# UNITED STATES PATENT AND TRADEMARK OFFICE

APPLICATION NO.	FILING DATE	FIRST NAMED INVENTOR	ATTORNEY DOCKET NO.	CONFIRMATION NO.
10/579,328	05/15/2006	Stephane Revol	290905US6X PCT	2136
22850	7590	06/09/2009		
OBLON, SPIVAK, MCCLELLAND MAIER & NEUSTADT, P.C. 1940 DUKE STREET ALEXANDRIA, VA 22314			EXAMINER MALEKZADEH, SEYED MASOUD	
			ART UNIT	PAPER NUMBER
			1791	
			NOTIFICATION DATE	DELIVERY MODE
			06/09/2009	ELECTRONIC

<b>Office Action Summary</b>	<b>Application No.</b> 10/579,328	<b>Applicant(s)</b> REVOL, STEPHANE	
	<b>Examiner</b> SEYED M. MALEKZADEH	<b>Art Unit</b> 1791

## **DETAILED ACTION**

FIG. 4A

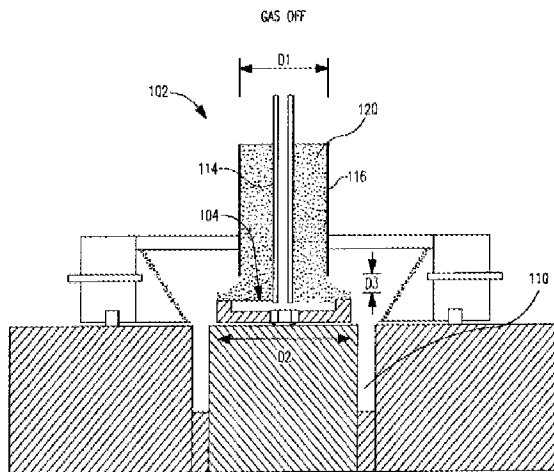
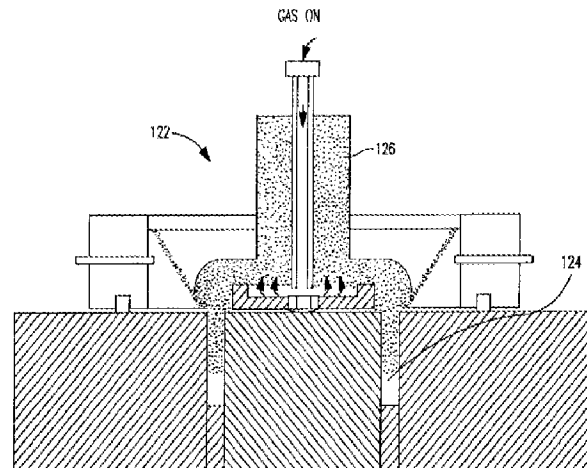
Zahrah et al (US '500) teach a delivery and filling system for filling a mould cavity (124) with a particulate material such as powder wherein the system comprises a mini-hopper (10) and collimator (126) as a means for adding at least one powder including a power inlet and a powder outlet in which the mini-hopper (10) has the same structural functionality as a receptacle, an individualized fluidizer (114) as an introducing pipe with an entrance orifice, a porous distributor plate (104) as a means for ejecting the powder added into a location of the device, and a bowl section positioned above the mold cavity (124) as a deflector in which locally intercept and redirect part of the powder ejected from the ejector means towards the mould cavity (124). (See lines 11-67, column 15 and figures 4A - 4B)

Zahrah et al (US '500) further teach the delivery chute (122) is centered above the die cavity (124) by pushing and moving the fill-shoe. (See lines 52-61, column 15) Therefore, the prior art teaches the deflector is mobile and orient-able.

Moreover, Zahrah et al (US '500) disclose the means (126) for adding powder includes a powder inlet and a powder outlet, and further the deflector is a part of an internal wall of the ejecting device.

The prior art, thus, meets all the claim limitations and therefore Zahrah et al (US '500) **anticipate** the claims 16-18, 26, and 29-33.

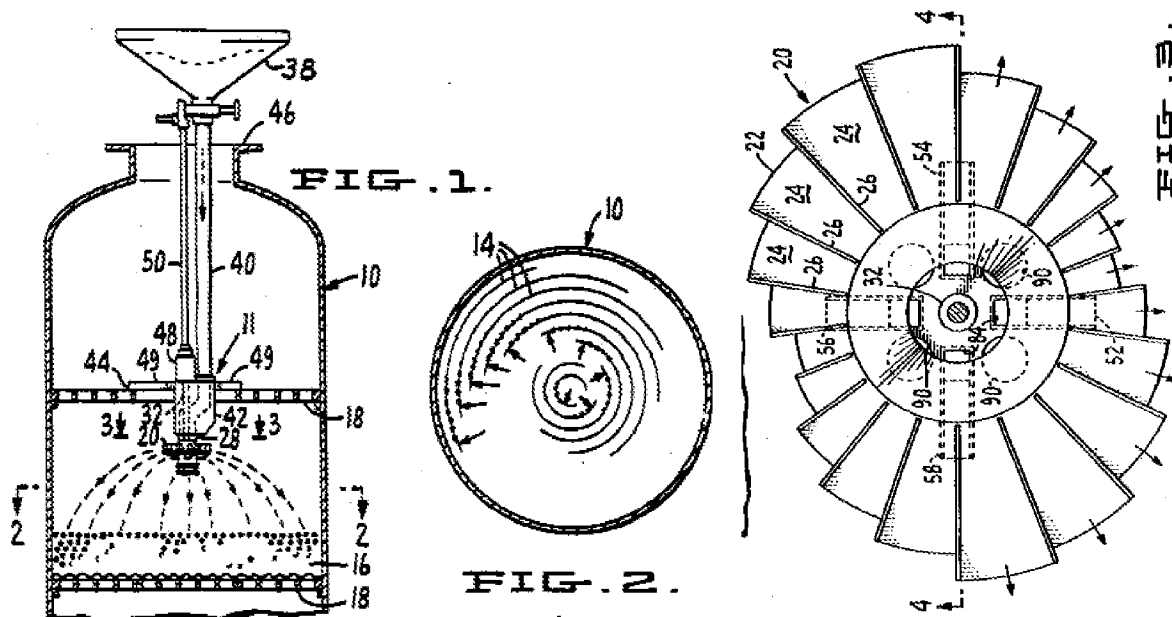
Zahrah et al. ('500) teach all the structural limitations of a device for filling at least one mold with the powder, as discussed above in the rejection of the claims 16-18, 26, and 29-33. Further, as recited above, Zahrah et al. ('500) teach a mean for ejecting the powder includes a tray as a lower part, a collimator (126) as an upper part and an entrance orifice (114) as a powder inlet and a powder outlet, wherein a space is located between the tray as the lower part and the collimator (126), as the upper part. (See figures 4A- 4B and 5B)

**However**, Zahrah et al. ('500) **fail to teach** rotating the ejecting means for ejecting powder as a rotating device which is in a shape of a disk, a cone, or a bowl, and includes at least one rib, as claimed in claims 19- 21 and 23- 24.

**In the analogous art**, Souers et al (US '202) teach an apparatus for simultaneously distributing particles across the full diameter of particles across the full diameter of the bed with a single rotor wherein the apparatus comprises a large diameter catalytic reactor vessel (10), a hopper (38), a supply tube (40), a catalyst loading apparatus (11), a lower feed hopper (42), a feed tube (28), and a catalyst distribution rotor member (20) as a disk-like rotating device in which the disk-like rotating device (20) comprises a plurality of sectors or segments (24) with rib members (26), a drive shaft (32) for the

rotation of the rotor member (20), (See column 7 and lines 12-50, column 8; further, figures 1 and 3) wherein the particles are distributed by the single disk-like member across the full diameter of the bed with substantially uniformly high density through forming a multiplicity of annular rings of the powder concentric with the center of the vessel or bed. (See lines 62-68, column 4)

**It would have been obvious** for one of ordinary skill in the art at the time of applicant's invention to modify the device for the powder filling of the mold as taught by Zahrah et al (US '500) through **providing** a disk-like rotating device with ribs as an ejection mean for the filling of the mold **in order to** uniformly distribute the powders within the mold cavity in such a way that the powders have a high density, as suggested by Souers et al (US '202)

FIG. 2

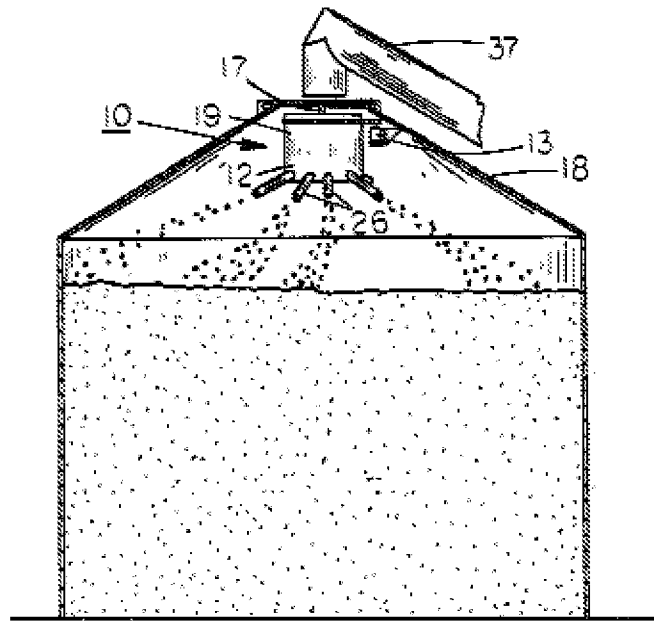
**However**, the prior art **fails** to teach the rotating device includes a curved tube, as claimed in claim 25.

**In the analogous art**, Olson et al. (US '613) teach a particle spreading apparatus as a powder spreading apparatus for dispersing particles in which the apparatus includes grain storage bin (18), a grain conveyor (37), a distributing apparatus (10) comprising a rotating shaft (17), a grain holding unit (12), a cylindrically shaped drum (19), and an output tube (26), wherein the particles holding unit may be selectively rotated about the mounting unit by appropriately controlling the motor in order to evenly distribute the particles throughout the particle storage bin. (See lines 60-68, column 2 and lines 1-20, column 3; figures 2-3)

**It would have been obvious** for one of ordinary skill in the art at the time of applicants' invention to modify the device for powder filling of the mold as taught by combined teachings of Zahrah et al. ('500) and Souers et al. ('202) through **providing** a curved tube for the rotating device of the ejection apparatus for distributing the powder within the mould cavity **in order to** effectively control the distribution of the powders through the mold cavity and also to fill the mould cavity with even layers of powder, as suggested Olson et al. (US '613)

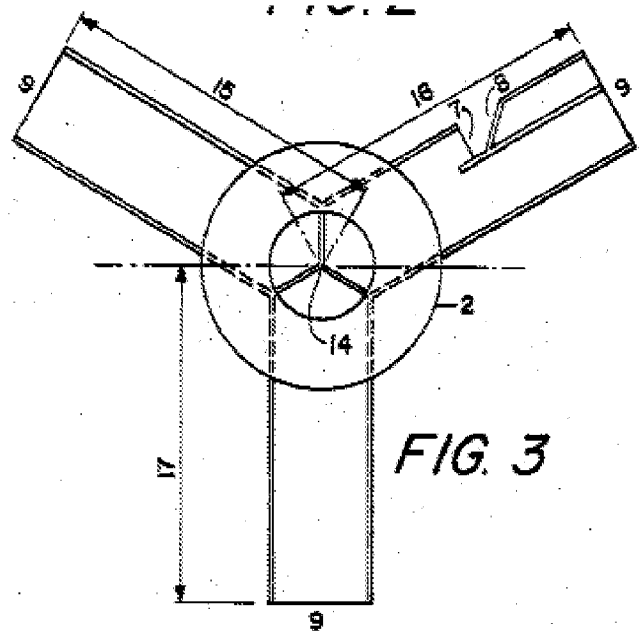
Zahrah et al. ('500) teach all the structural limitations of a device for filling at least one mold with the powder, as discussed above in rejection of claims 16 – 18, 26, and 29- 33. **However**, Zahrah et al. ('500) **fail** to teach at least one deflector is placed in parallel with a rotation axis so as to be perpendicular to a median ejection plane of the powder layer, as claimed in claims 27 and 28.

**In the analogous art**, Bottoms (US '887) teach a rotary distributor apparatus (1) with inclined conduits stream dividers and multiple discharge ports comprising a receiving mean (2), an optional dust shield (6), a conventional bearing (5), a fixed support (4), distributing conduits (3), drive means (20) which rotates the receiving mean (2), and dividers (7 and 21) as deflectors, wherein the powder material can be uniformly distributed in a vessel by amount and by particle size radially from the axis of rotation at each level in the vessel, (See lines 15-22, column 1) and, further, the dividers (7 and 21) as deflectors divide a stream of particulate material passing downwardly through the conduit (See lines 39-47, column 1) in which the deflectors (7 and 21) are in parallel with the rotation axis of receiving means (2) and also the deflectors (7 and 21) are in perpendicular position relative to the plane in which the fixed support (4) is positioned. (See figures 1 and 3)
